## HOUSE GOVENDER DEVIATION TO APPROVED PLAN NO : 102 09 13

LIST OF DEVIATIONS

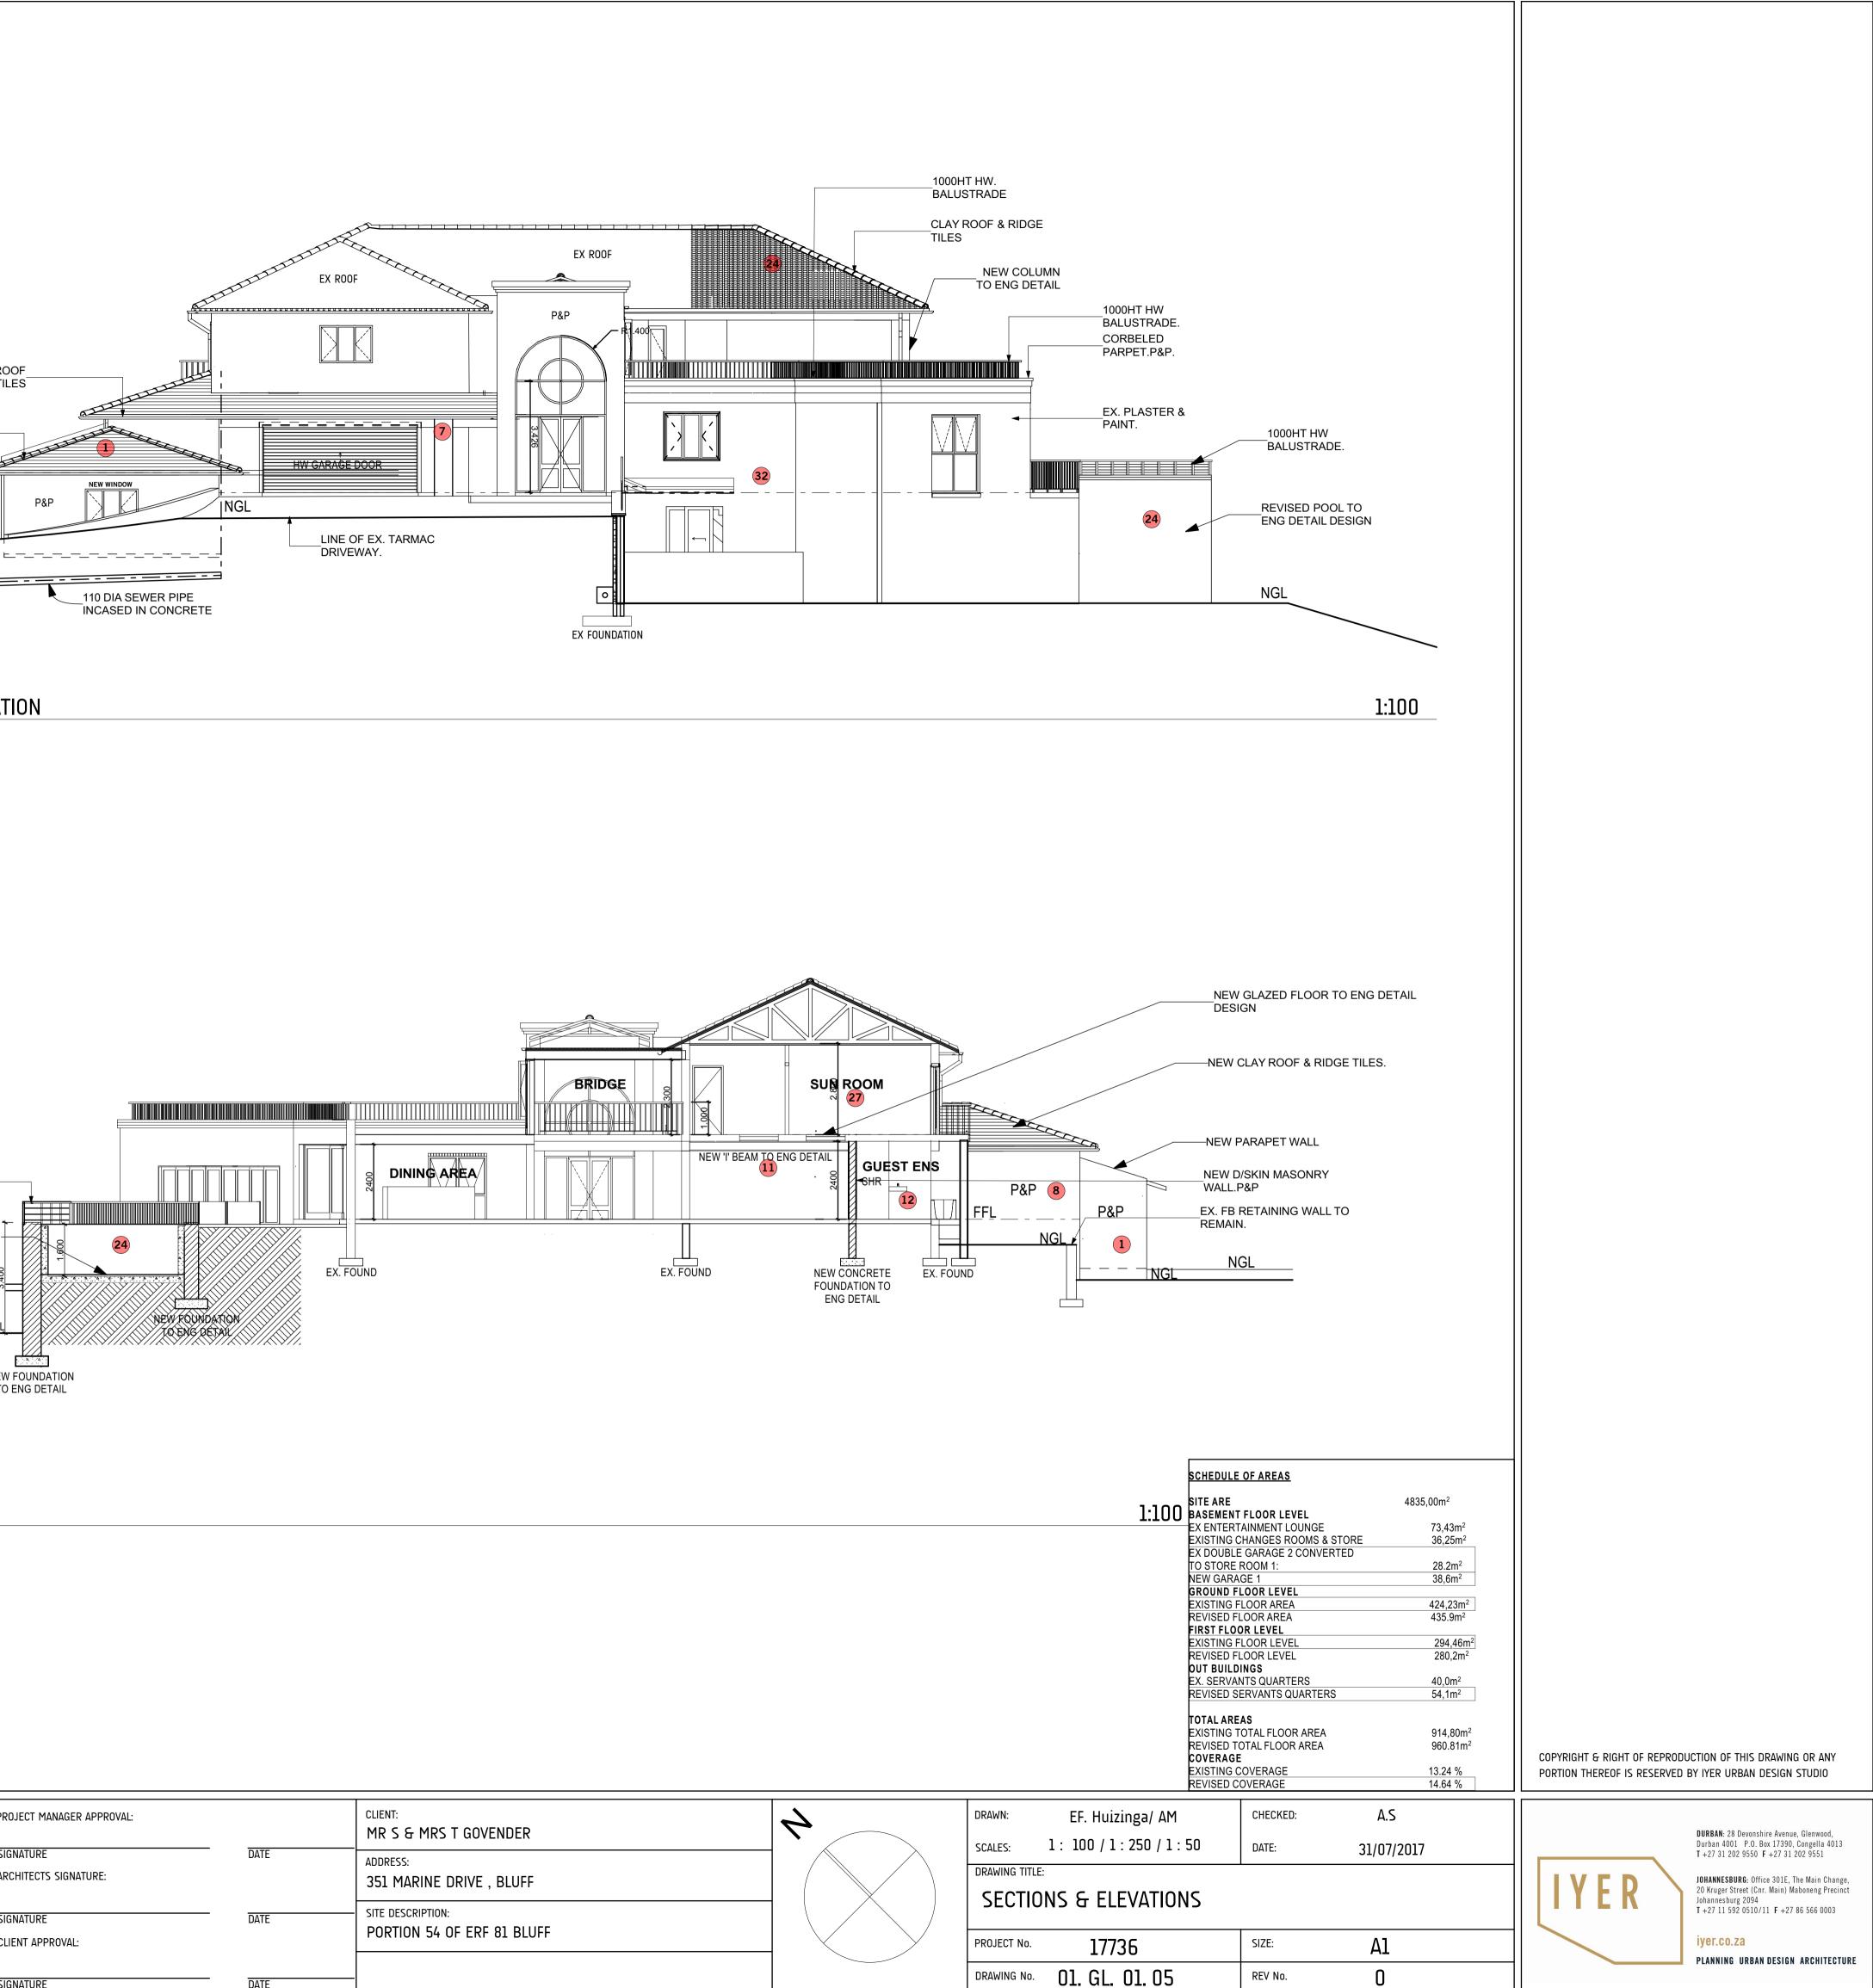
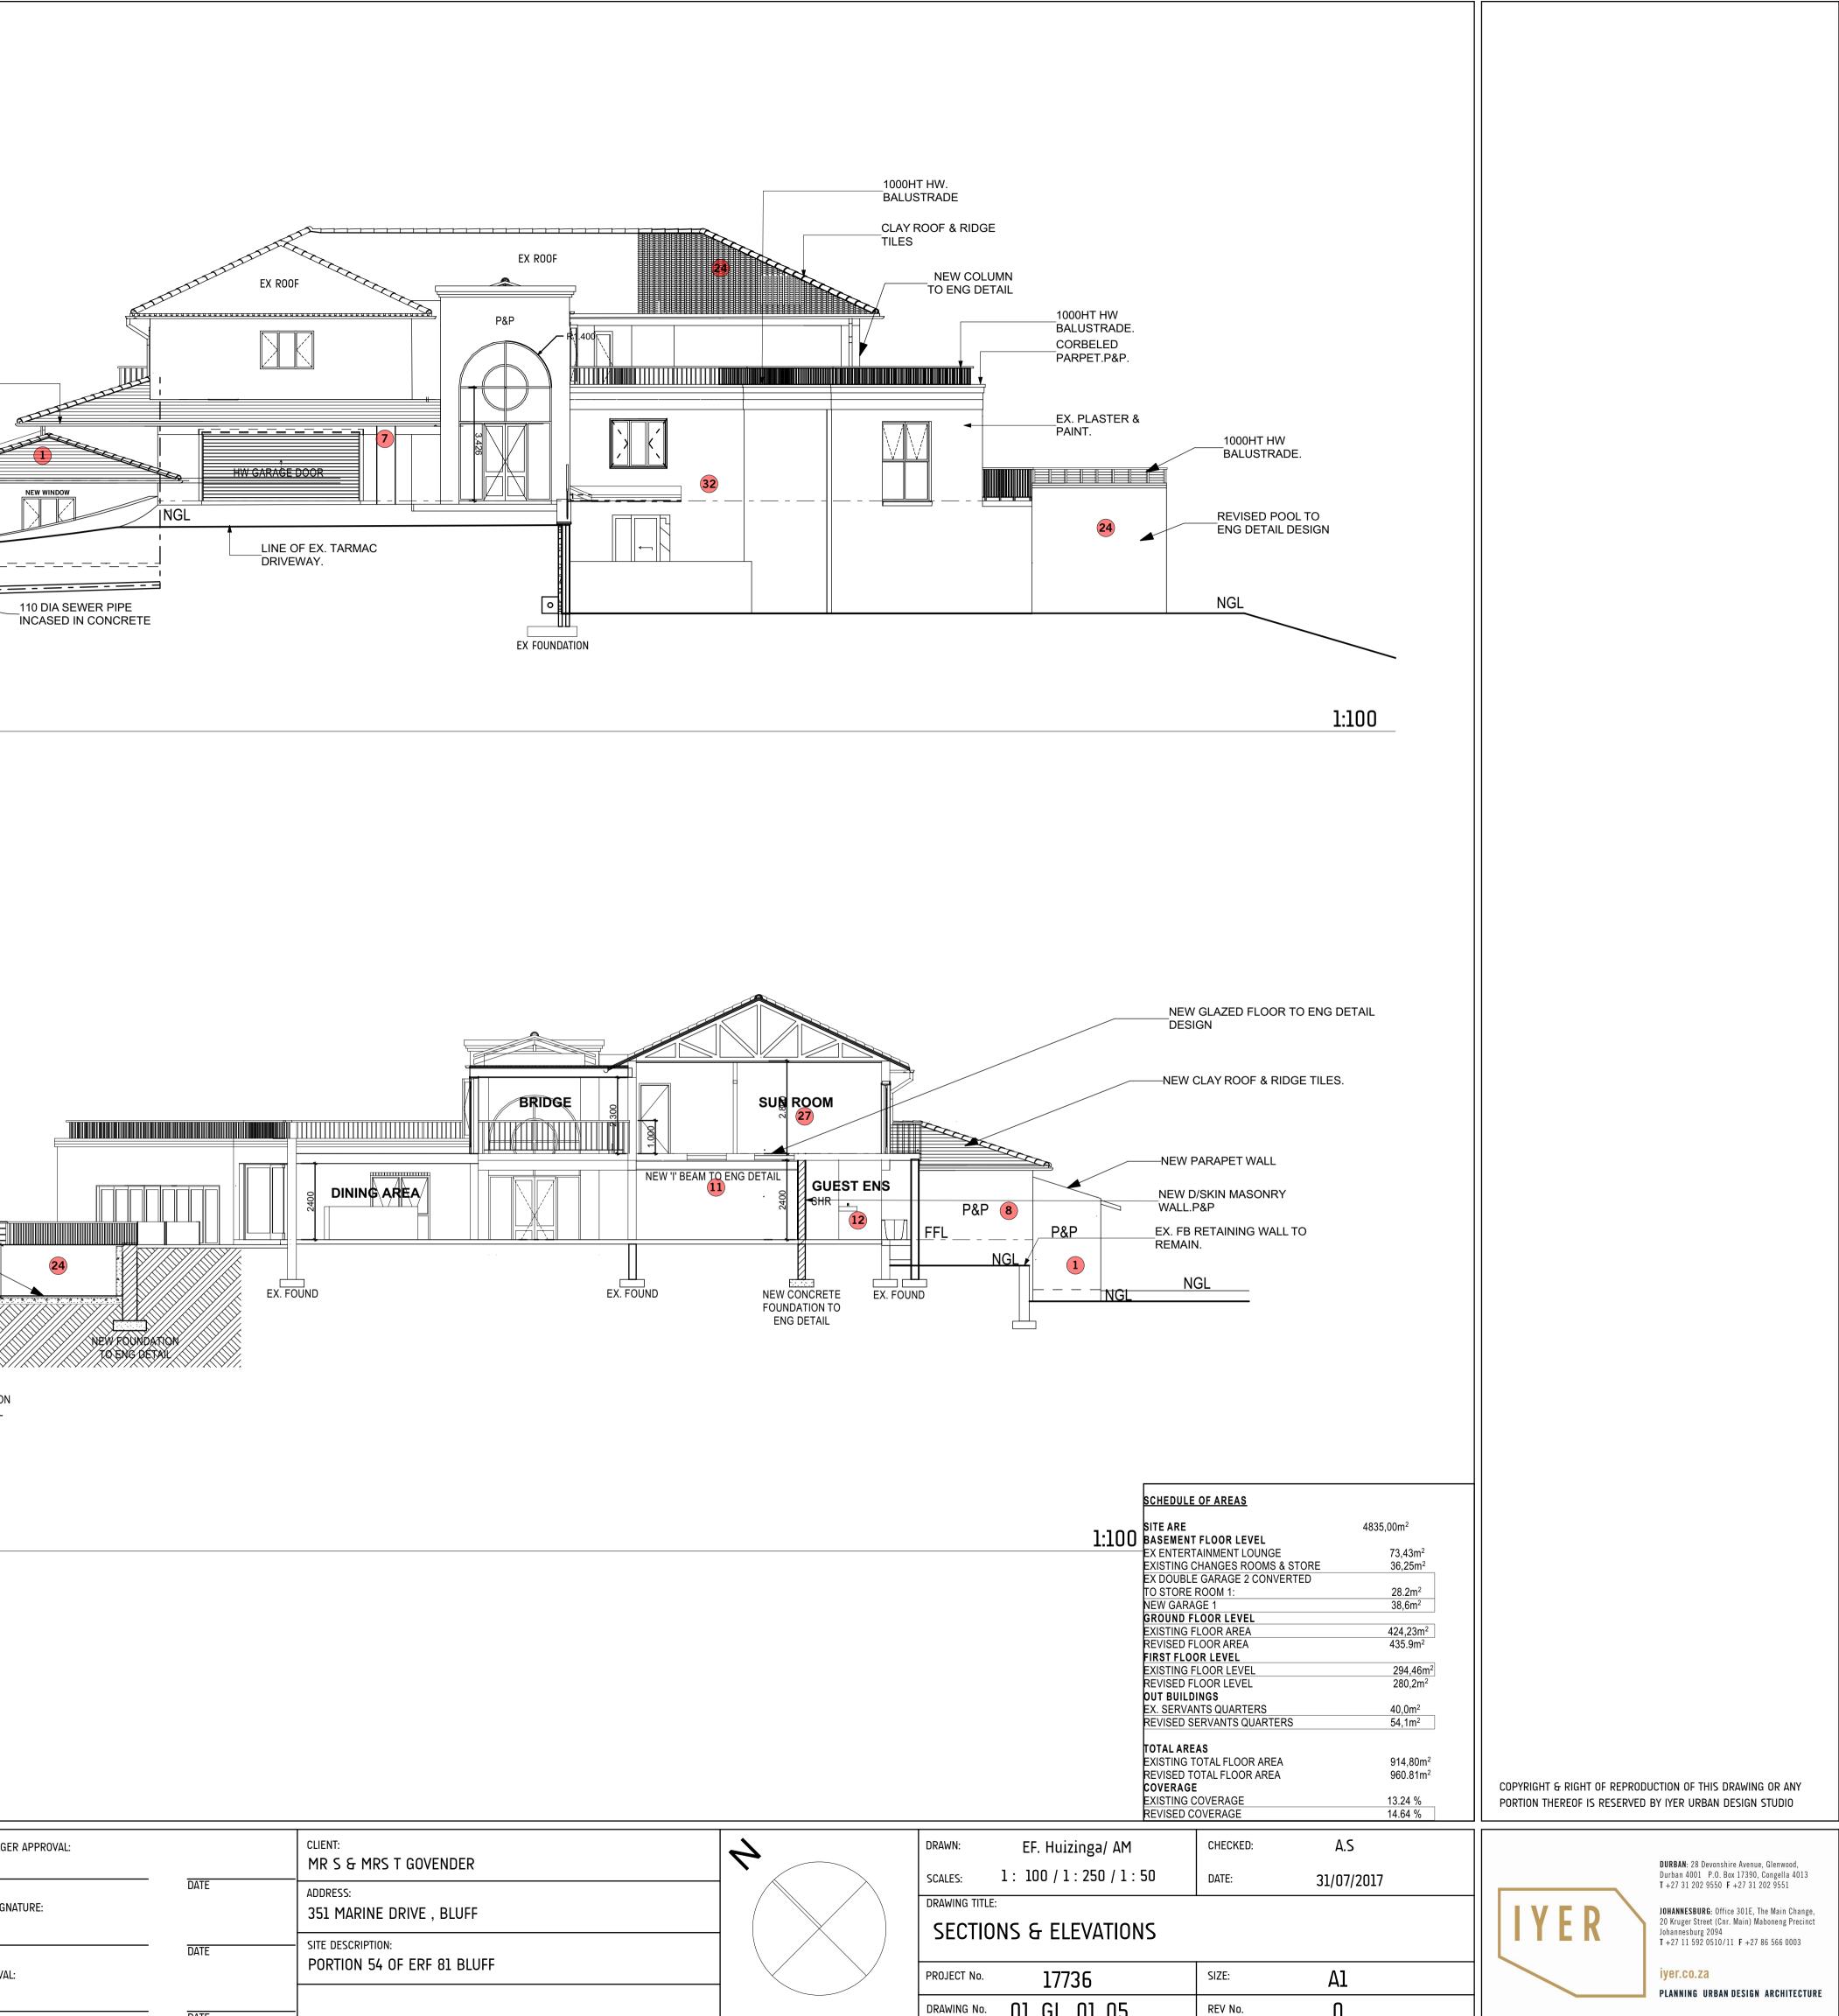
8 EX OFFICE CONVERTED INTO NEW GUEST BEDROOM 1 WITH EN-SUITE 9 NEW RC SPIRAL STAIR CASE & NEW PLAY AREA TO ENG DETAIL **10** REVISED GUEST TOILET LAYOUT **11** NEW STEEL 'I' BEAM TO ENG DETAIL **12** REVISED GUEST BEDROOM 1 & EN SUITE LAYOUT **13** REVISED KITCHEN LAYOUT **14** REVISED TV LOUNGE LAYOUT **15** REVISED SCULLERY LAYOUT **16** REVISED EX PATIO (ADDED NEW STAIRS & BALUSTRADES) **17** REVISED DRYING YARD AREA **18** REVISED COVERED PATIO LAYOUT NEW OUTSIDE ENTERTAINMENT AREA WITH 23 JUCUZZI AND TIMBER DECK TO ENG DETAIL 24 NEW SWIMMING POOL LAYOUT TO ENG DETAIL DESIGN 25 REVISED BEDROOM 3 & EN-SUITE

**19** NEW CONCRETE STAIR ADDED **22** NEW PRE-CAST OUTSIDE STAIRCASE TO ENG DETAIL DESIGN

**21** NEW TIMBER FENCE ALONG SIDE BOUNDARY 1.8 METERS IN HEIGHT

2 EX STORE CONVERTED INTO STAFF CHANGE ROOM

**7** NEW TIMBER LAMINATED BEAM & NEW COLUMN TO ENG DETAIL

EX SERVANT'S QUARTES EXTENDED 4 EX SERVANI'S QUARTES EATLINES WITH NEW LOUNGE AND KITCHEN

1 NEW GARAGE

**5** NEW JOJO TANKS

6 NEW TIMBER RAMP

26 REVISED BEDROOM 2 & EN-SUITE

**28** NEW GLAZED FLOOR TO ENG DETAIL & SPEC

**32** NEW ROOF OVERHANG FIXED TO EXISTING WALL

27 REVISED SUN ROOM

29 REVISED LINEN ROOM

(30) REVISED MAIN BEDROOM

**31** REVISED DRESS ROOM

20 NEW OUTSIDE SHOWER
